Item ID: D212-664-201

Item Name: Crosstube Aft

DART AEROSPACE LTD		Work Order:	90SS0
Description: Crosstube High Aft (205/212)		Part Number:	D212-664-201
Inspection Dwg: D212-664-241	Rev: D	Page 1 of 1

DRAWING NO. D212-664-241	TITLE CROSSTUBE ASSY (205/212 HI AFT)	REV. D	DART AEROSPACE LTD ENGINEERING ORDER		D.E.O. NO. D212-664-241-D-1	SHEET NO. SHEET 1 OF 2	SCALE NTS
DRAWN	CHECKED	MFG. APPR.	APPROVED	DE APPR.			
DATE 11.04.07	DATE 11.04.11	DATE 11.04.12	DATE 11/04/12	DATE 11.04.12

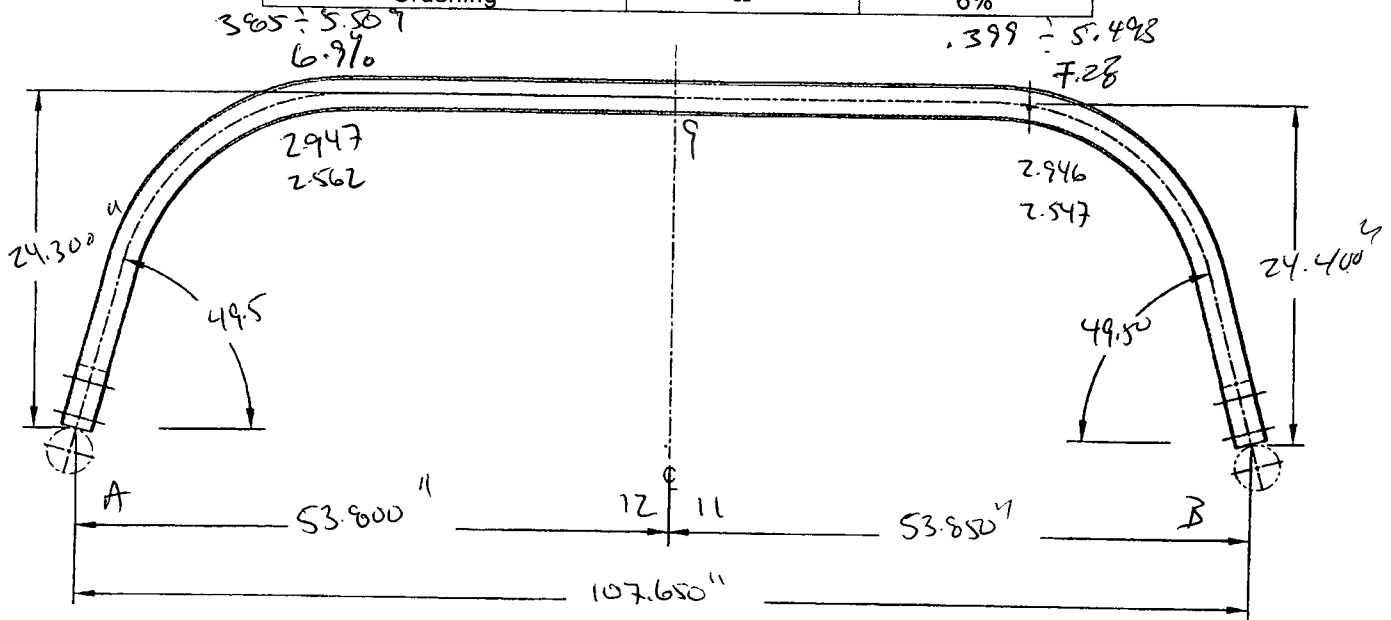
Side A	Middle	Side B
Bending Passes	12	9	11
Crushing	6.9%		7.2%
Comments			
Side A = 6.9% crushing @ 12 Passes			
Middle = 9 Passes			
Side B = 7.2% crushing @ 11 Passes

FIGURE 1: SUPPORT INSTALLATION

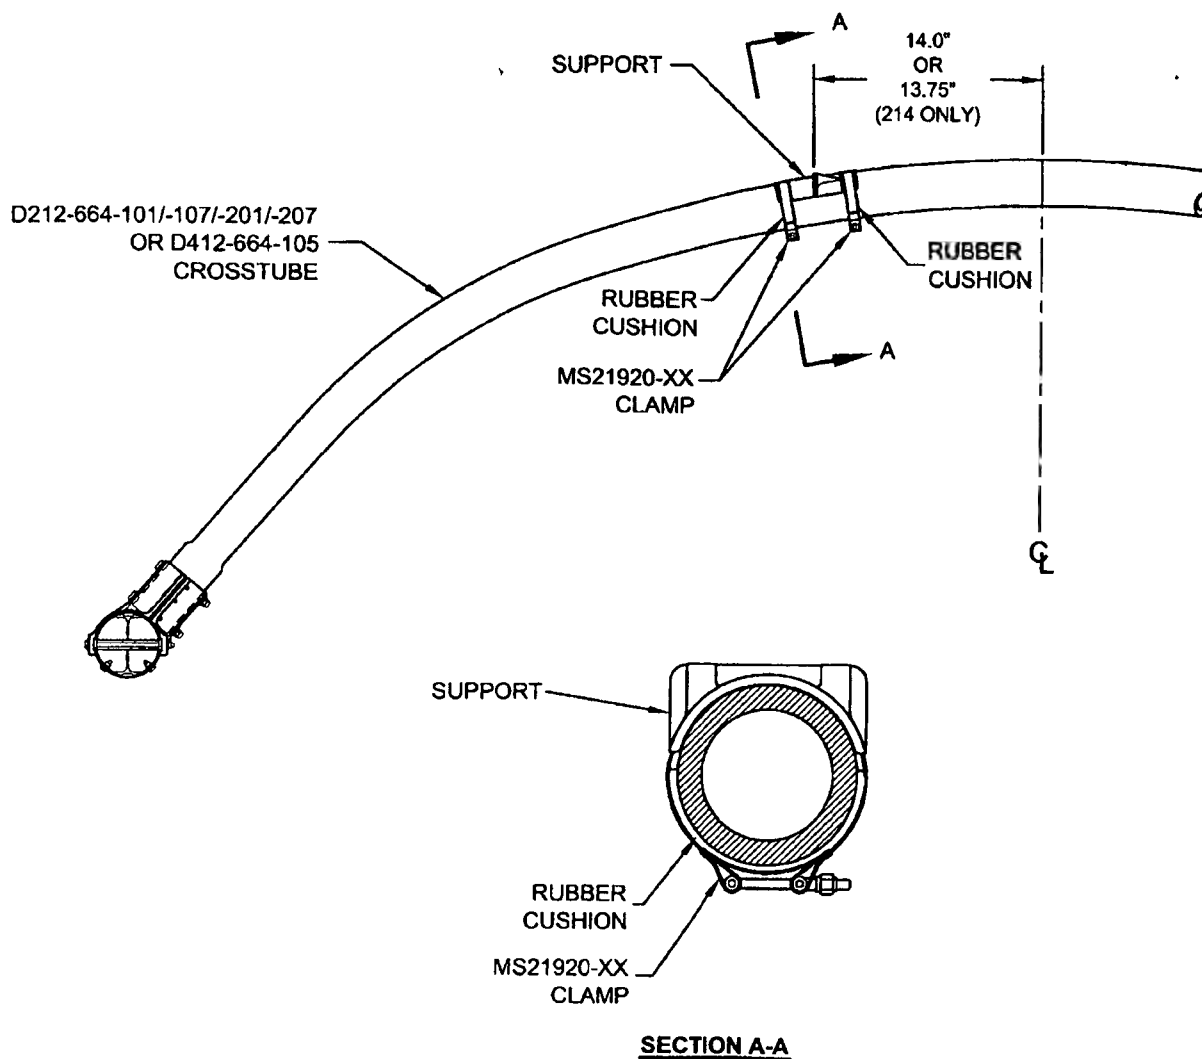
The supports on the following crosstubes are now installed using Proseal instead of Magnobond:

For the crosstubes listed above, section 32.4 of ICA-D212-664 is amended as follows. Use Figure 1 of this service instruction and Figures 32-2 to 32-9 of ICA-D212-664 for further reference. For crosstubes of an earlier change number, it is recommended that if the supports are removed, the supports should be reinstalled using the procedure listed below.

- 32.4.5 Apply a 0.04" to 0.07" thick layer of Proseal 890 Class B or AMS-S-8802 Class B sealant underneath applicable support and install support as shown in Figure 1 of this service instruction.

- 32.4.6 Install the clamps opposite to crosstube support as shown in section A-A of Figure 1. Install rubber cushions underneath each clamp around the bottom circumference of the crosstube up to the crosstube centerline. Torque clamps 80-100 in·lb (9.0-11.3 Nm). It is acceptable to use smaller or larger sized MS21920-XX clamps than those listed in ICA-D212-664, ensure that after torquing the clamps per this instruction, the nuts are in safety but not bottomed out

D212-664-241/-241B
ASSEMBLY DETAIL

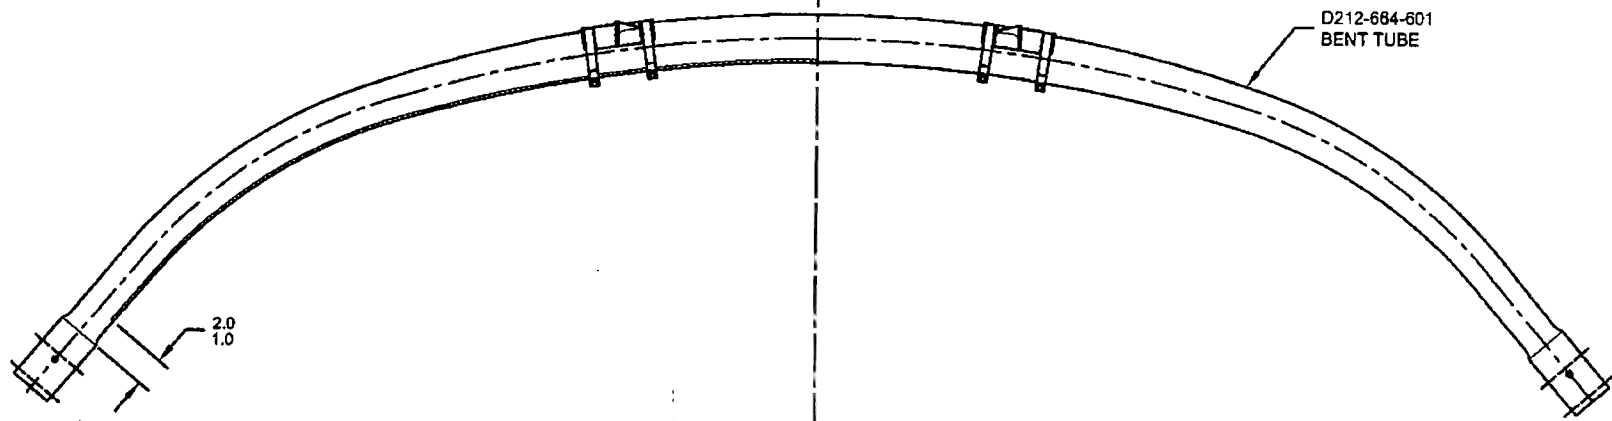
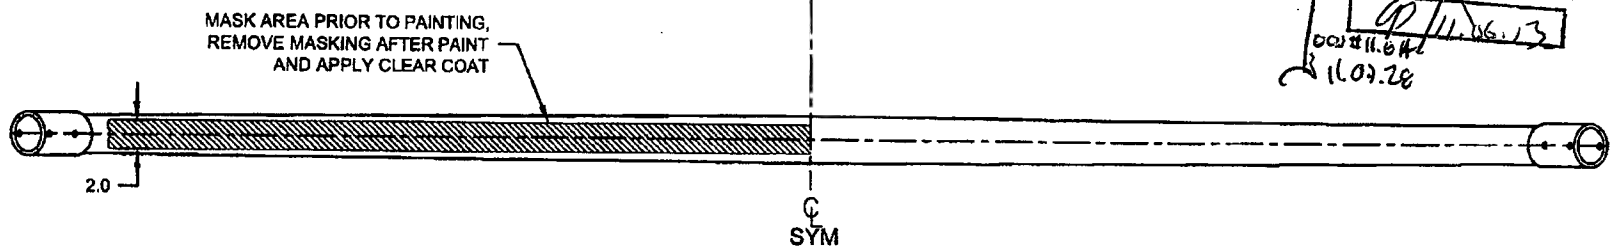
ADD AN INSPECTION WINDOW TO UNDERSIDE OF CROSSTUBE.

NOTES 2 OF SHEET 1 IS AMENDED AS FOLLOWS:

- 2) FINISH: CHEMICAL CONVERSION COAT PER DART QSI 005 4.1
PRIME INSIDE AND OUTSIDE PER DART QSI 005 4.2
MASK UNDERSIDE OF CROSSTUBE AS SHOWN (HATCHED AREA) AND
PAINT OUTSIDE PER DART QSI 005 4.2
REMOVE MASKING AND APPLY CLEAR COAT

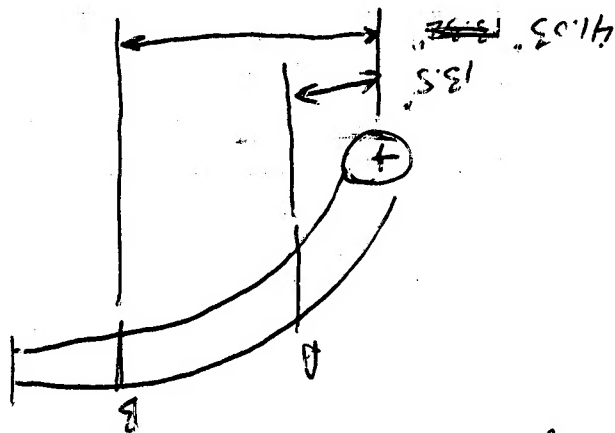
REPLACE MAGNOBOND WITH PROSEAL.

NOTE 12 & 15, SHEET 1 IS AMENDED AS FOLLOWS:

- 12) TO INSTALL D2940-1 SUPPORT: ABRASE MATING SURFACE OF SUPPORT AND CROSSTUBE WITH 180-GRIT SANDPAPER AND REMOVE RESIDUE WITH MEK (OR EQUIVALENT). APPLY A 0.04" TO 0.07" THICK LAYER OF PROSEAL 890 CLASS B-2 (OR AMS-S-8802 CLASS B-2) SEALANT TO MATING SURFACE OF SUPPORT.
- 15) TORQUE CLAMPS 80 TO 100 IN.-LB. ENSURE AT LEAST 1.5 THREADS SHOWING IN SAFETY AND THAT NUT HAS NOT BOTTOMED-OUT AFTER TORQUING. **PRIOR TO PACKAGING, RE-CHECK TORQUE ON CLAMPS AFTER PROSEAL 890 SEALANT HAS CURED FOR 72 HOURS.**
